REMARKS

Application No.: 09/394,918
Examiner: O. Flores-Sanchez
Art Unit: 3724

FIG. 1 (PRIOR ART)

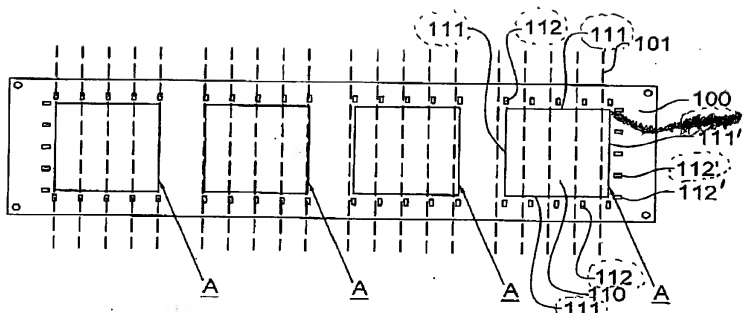
FIGs. 1-5 have been amended on attached amended drawing sheets 1-2 which replace original drawing sheets 1-2 including FIGs. 1-5. In FIG. 1, reference numerals 111' and 112' have been added to designate an outermost alignment mark and outermost cutting marks, respectively, and further reference numerals 111 and 112 have been added to designate further alignment marks and cutting marks, respectively. In FIGs. 1-5, solid lines have been changed to broken lines to indicate cutting tracks 101, 102.
